Project Name: Willow Ridge

REVIEW COMMENTS

FILE #190-94

TITLE HEADING: Preliminary Plan - Willow Ridge Subdivision

PRELIMINARY STORMWATER
MANAGEMENT PLAN
& SHEET 2
PRELIMINARY PLAN

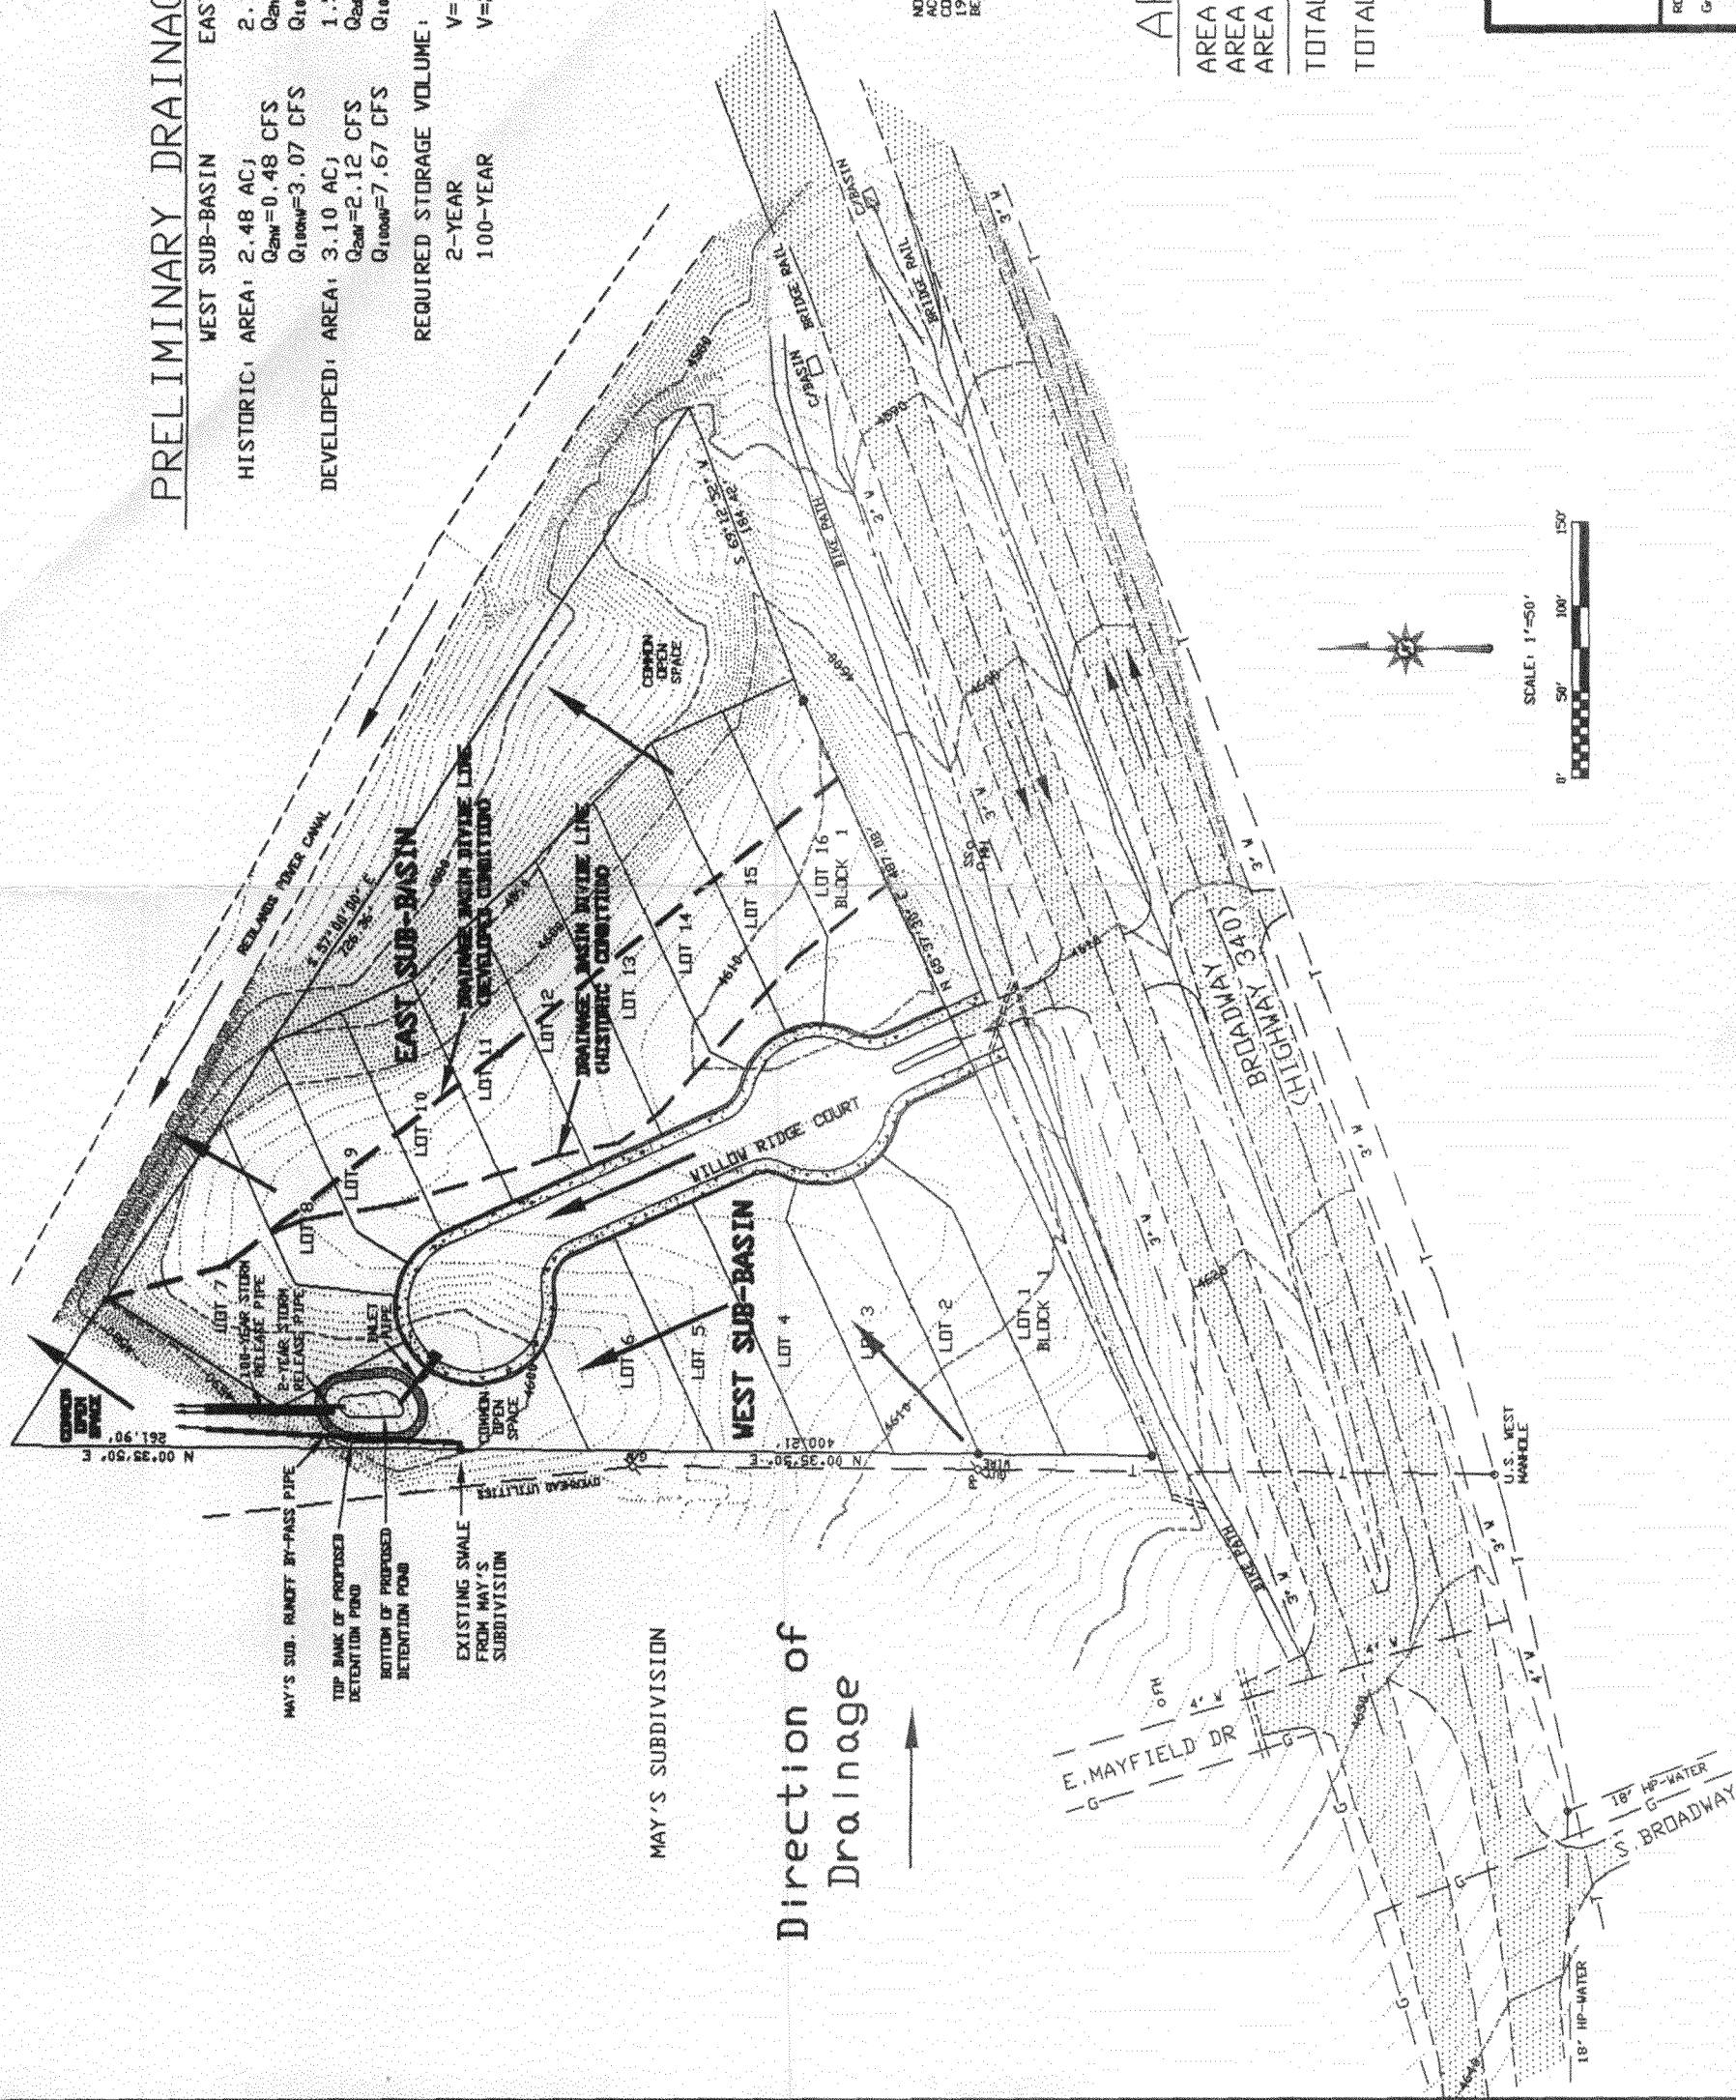
1. Running an 8" line to the end of the development is not necessary to provide adequate fire protection. The last fire hydrant needs to be within 250' of Lot 7.

1. Show proposed flowline, rim elevations and slopes on pipes to insure this alignment will work.
2. Provide 15' utility easement across Lot 11 and write plat dedicatory language so "common open space" is also utility easement.
3. Can all lots be served by gravity flow into the main?

Existing hydrant at Brach's Market flows over 1,600 GPM, so extension of line to Willow Ridge should provide adequate fire flows. The locations of proposed hydrants at Willow Ridge is acceptable.

1. The drainage plans as submitted on the preliminary, with the retention pond and controlled drain, are acceptable to Redlands Water & Power. If any changes are made, Redlands reserves the right to review and approve the changes.
2. A "Hold Harmless" clause from any contaminates in the water or drainage that flows into Redlands Power canal will be included in the covenants.
3. A set of plans or drawings are to be presented to Redlands for approval prior to installation of a domestic water line attached to the bridge that crosses over Redlands Power canal on Highway 340.
4. A copy of the soils report shall be provided to Redlands.
5. A copy of the covenants showing the "Hold Harmless" clause shall be provided to Redlands.
6. A fence on the outside perimeter toward Redlands Power canal is recommended to discourage homeowners from throwing debris into Redlands Power canal.

- 1) The access permit to Highway 340 is limited to 16 single-family residences. The proposed 16 units does not exceed this number.
- 2) The proposed number of individual lots (16) is a reduction of three from the previous development (#146-94) which was denied by the Planning Commission at the October meeting. As in the previous review, 10 to 12 lots are still preferred.
- 3) Lot configurations are a concern with this proposal as they were in #146-94. This

proposal indicates that all lots will have minimum street frontages of at least 20 feet. However, Lots 2 and 15 gain this minimum because of the expanded girth of the street. Of similar concern is the lot depth to lot width ratio. These vary from roughly 3:1 to more than 6:1. These ratios are indicative of lot configurations which are awkward, inefficient and distortional.

5) The proposed street contains a undesirable aspect discussed above, that being the bulge at the southern portion of the proposed Willow Ridge Court. Although variation in streetscapes are desirable, either by enhancement with features such as landscaping, street lighting and street furniture or by a curvilinear design of the street (or by combining elements of both), the proposed bulge does not provide these kinds of amenities.

7) Drainage is a concern on the site. Previous comments from the Redlands Water and Power Company stated that discharge would not be permitted into the canal. The petitioner has proposed a detention pond on the north portion of the site, northwest of the street terminus. The adequacy of this facility can only be determined by Engineering staff.

1. Full utility composite, including the sewer profile will be submitted at final as required.
2. Utility easements will be shown as suggested.
3. Preliminary studies show the proposed alignment will accommodate the proposed units.

3. Lot configurations for lots 2 and 15 were adjusted to allow drive access around the entry median. If the median can be configured to allow an entry feature, we would hope to configure the lots to allow easy access. The lot depth to width ratio is a result of the desire by staff to eliminate the, and I quote the Staff review, "three separate designated 'open space' areas which do not function in any coordinated manner. In fact, the open space area on the southwest corner of the site is useless." If it isn't to be lot or open space, I request a designation which provides a use for the land that is acceptable. I would also request a townhouse lot which keeps the ratio you request. If the unit is 30' in width, a common width, it is then restricted to a 90' length. Eliminate the 20' for the parking in the drive, the 20' for the garage, the desired 25' rear yard setback, and you are then restricted to a 30 x 25' unit. Enclosed are examples of this type of zero lot line unit.

5. The proposed widening of the street was to offer variation and interest. In response to the objections of Planning and Engineering, we have offered alternates without the widening.

7. The City Development Engineer, petitioner's engineering and planning representatives have met with Redlands Water & Power and addressed their concerns. The detention pond volume has been addressed at the preliminary stage and the volume can be handled on site.
